2RF-166 -
MOBLEY
CONTAINMENTS #1
AND #2 FACILITY ID
fVV2131951088
C-147/Conditions of
Approval/
Correspondence

[371643] SOLARIS WATER
MIDSTREAM, LLC
January 20, 2022

Recycling Facility and/or Recycling Containment

Mobley Containments #1 and #2 & Mobley AST Containment.

Figure 2: Chemically weathered gypsum near the anchor trench of the northern excavation; Liner installation in top-background.

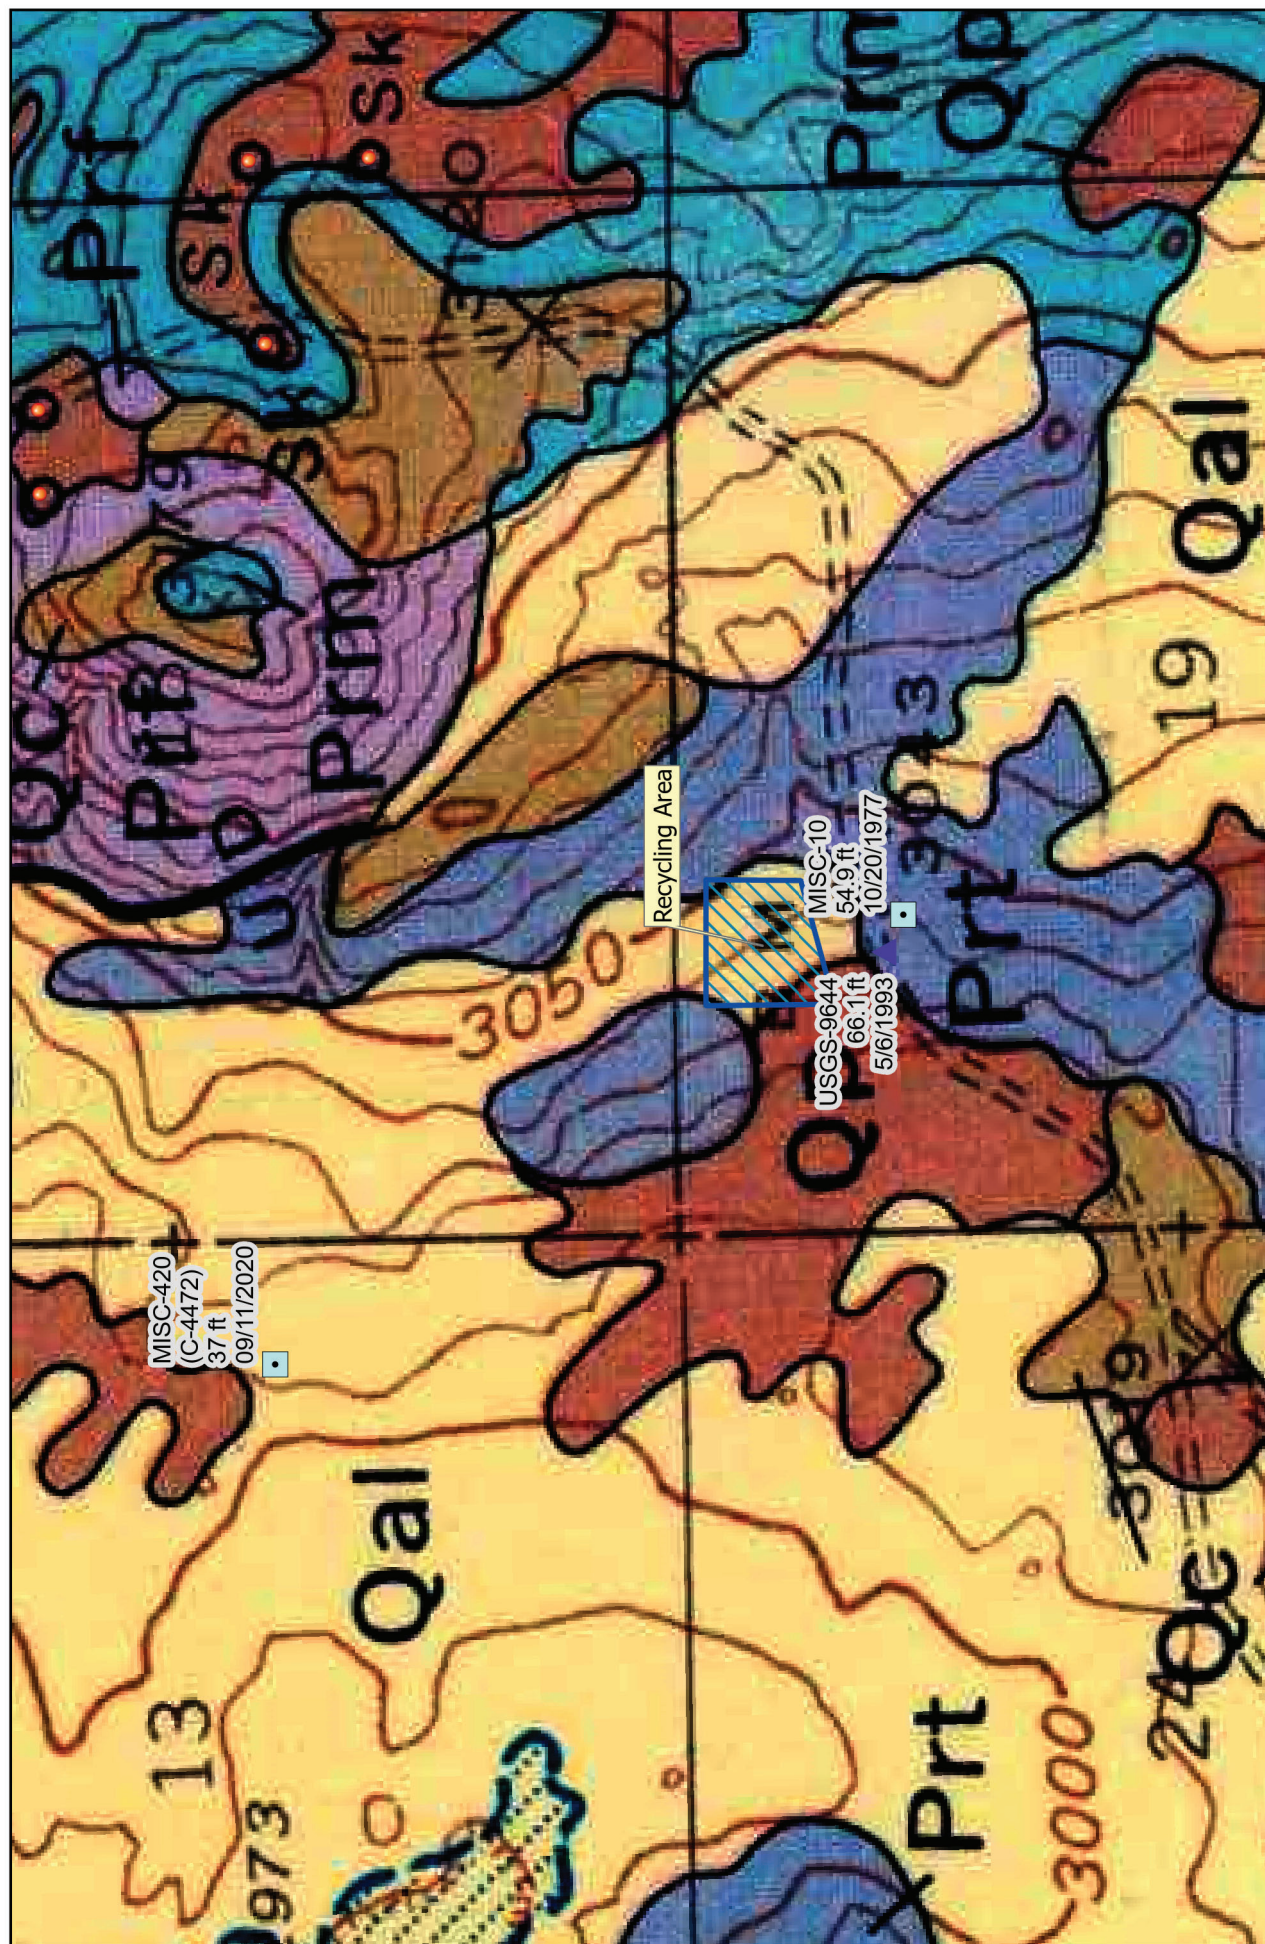
- 1) Given the proposed recycling facility is in a high karst area, [371643] SOLARIS WATER MIDSTREAM, LLC needs to conduct a Geotechnical Survey including Ground Penetrating Radar and submit to NMOCD the interpretation of results.*

Observations, geologic knowledge, accounts from the excavator and examination of nearby sinkholes and the domal karst hill to the northeast (see Figure 1b) permit a conclusion that erosion of gypsum occurred within small drainage channels as described in the C-147 and presented in the site photos. Erosion removes near surface weathered gypsum from active channels (see site photos). Changing channel patterns with subsequent channel filling by alluvium allowed infiltration of precipitation to focus chemical weathering in the former channel at the contact between gypsum and the overlying, thin alluvium. We contend that the west-southwest slope of the ground caused by the karst dome to the northeast prevented ponding of water, as is true today, and caused spatially limited and shallow dissolution of the underlying massive gypsum.

The site investigation of Mr. Hicks and this investigation by Ms. Pope did not identify any voids, cavities, or other evidence of instability. During excavation and hammering of the massive gypsum horizon, the contractors did not encounter instability or voids.
